Drain: LYNNWOOD HILLS DRAIN **Drain #:** 152
Improvement/Arm: LYNNWOOD HILLS - SECTION 2
Operator: JDH **Date:** 4-15-04
Drain Classification: Urban/Rural **Year Installed:** 1983

GIS Drain Input Checklist

To: Hamilton County Drainage Board

Re: Lynnwood Hills Drain Project

LYNNWOOD HILLS
OFFSITE DRAINAGE PLAN

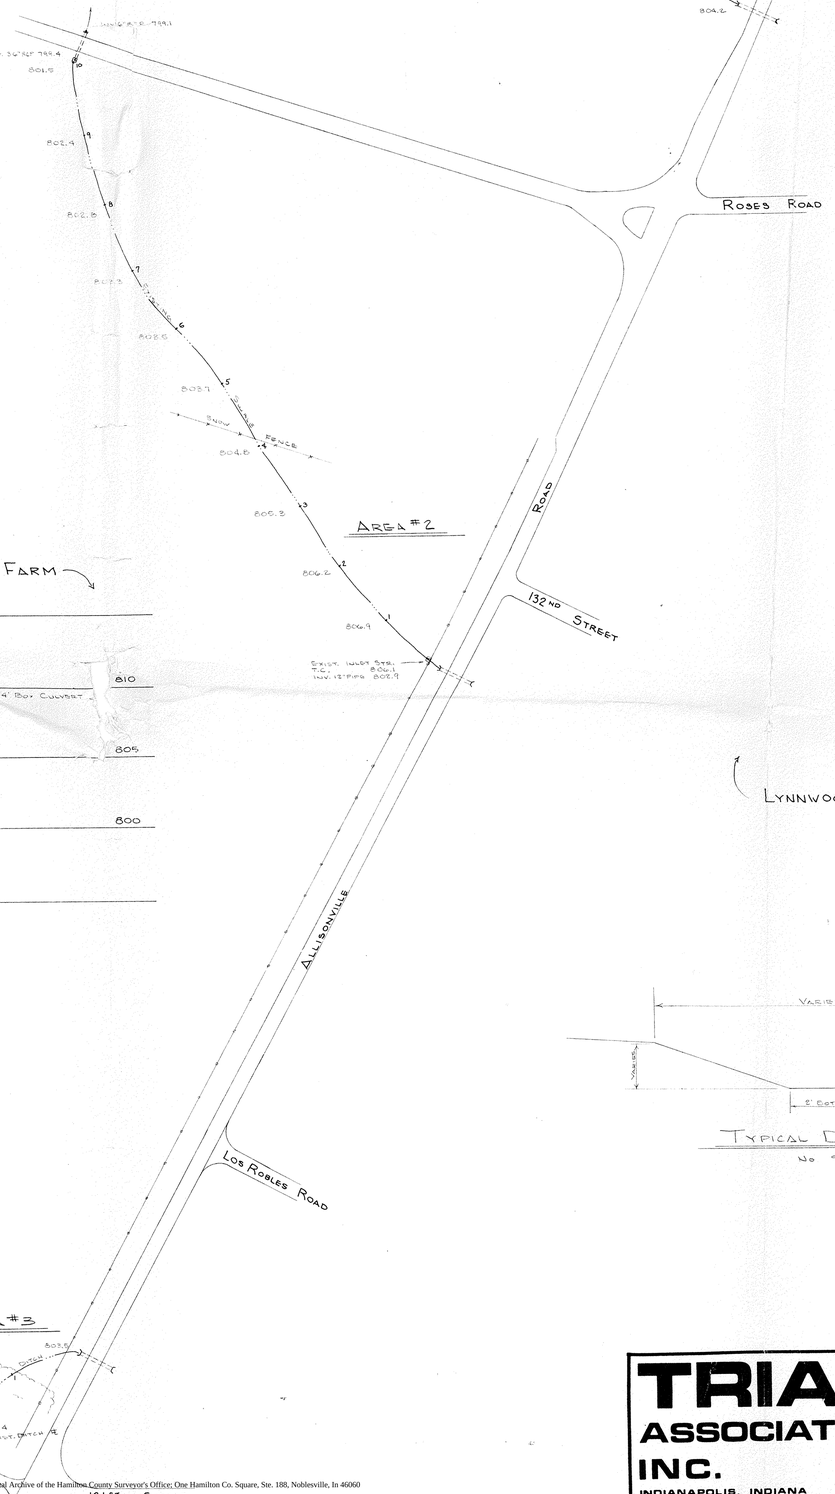
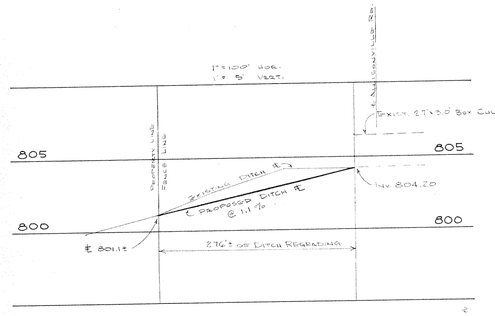
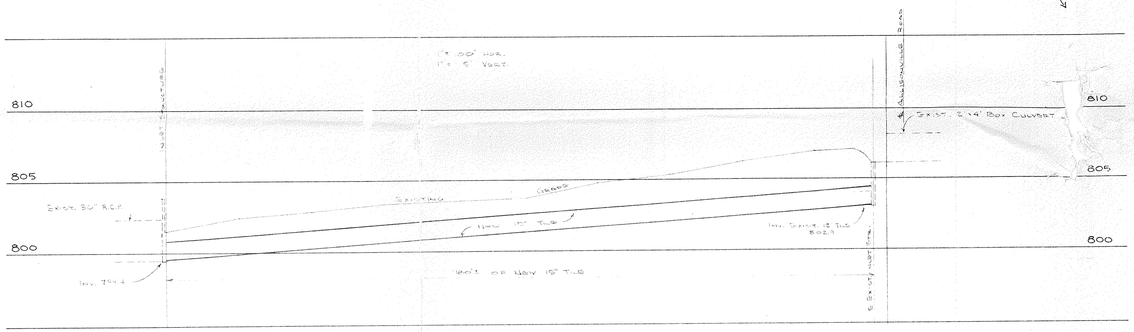
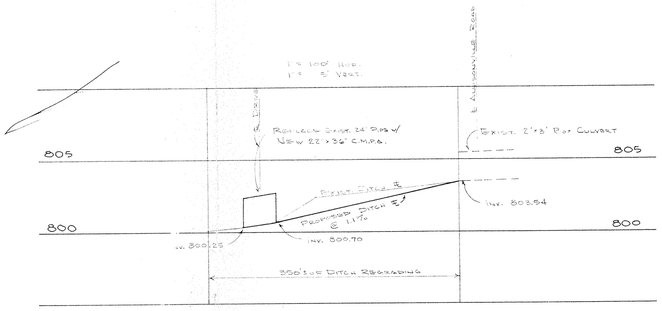
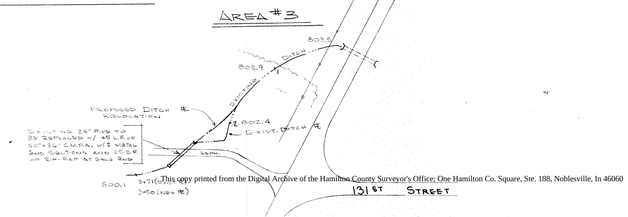
More explanation and detail is needed on sheet 19 which covers work needed on the Conner Prairie Farm. This includes cross sections and profile of the open ditch work on the north and south discharges. The south discharge plan should also show the riprap plan for the corner south of the lane, new pipe under the lane and straightening curve in ditch north of the lane. A note should be placed on the plans stating the Contractor is to locate existing 12" tile so that new 15" can be placed parallel to it on approximately the same grade.
